brian
cooper
consulting

12 January 2011

- presents my final findings on a review of the operation of Wivenhoe Dam (including controlled releases) for compliance against the Flood Mitigation Manual for the period 12 December 2010 to date (Flood Event), and;
- provides advice on the prudence and appropriateness of the decisions and actions taken during the Flood Event regarding the operation of Wivenhoe Dam in light of the Flood Mitigation Manual's requirements and the circumstances of the Flood Event.

Wivenhoe & Somerset Dams – Storage Level Behaviour (as presented in Technical Situation Reports)

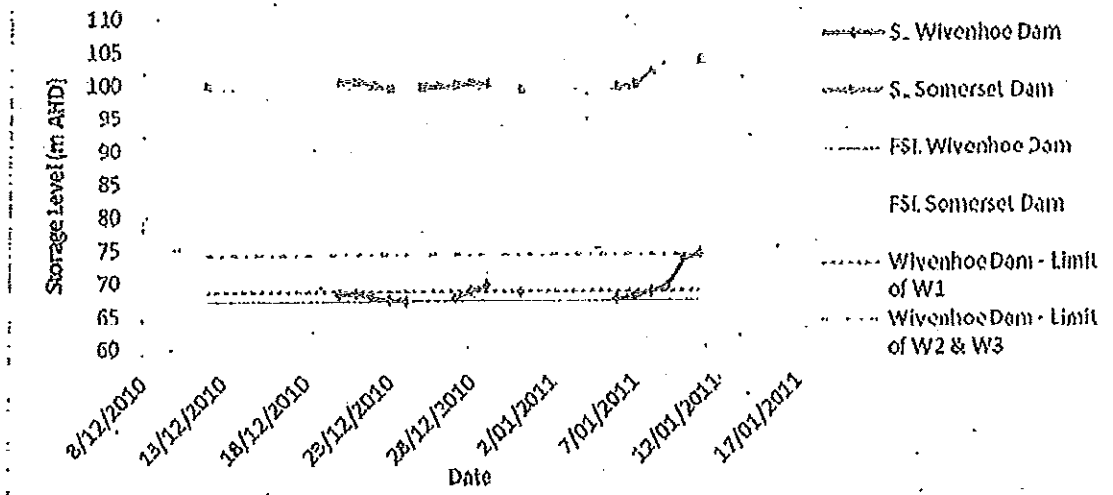
The Technical Situation Reports comply with the requirements of the new Communication Protocol. However, I feel that there could be more consistency in the information presented. There seem to be gaps in information presented such as storage levels (see spreadsheet and graph in Attachment A). It would be useful to specify the minimum information required to be presented in the Technical Situation Reports (storage levels, inflows, recent/current rainfall, forecast rainfall, releases from dams, estimated flows from downstream tributaries, current flood operating strategy for each dam and proposed change in strategy, gate and regulator operations, state of downstream road crossings etc). Most of the minimum information is already given, but not in a consistent manner. As a means of reviewing processes followed during a flood, it would be useful to present a timeline of the flood event showing graphs of storage levels and other data that can be easily presented in a graphical manner.
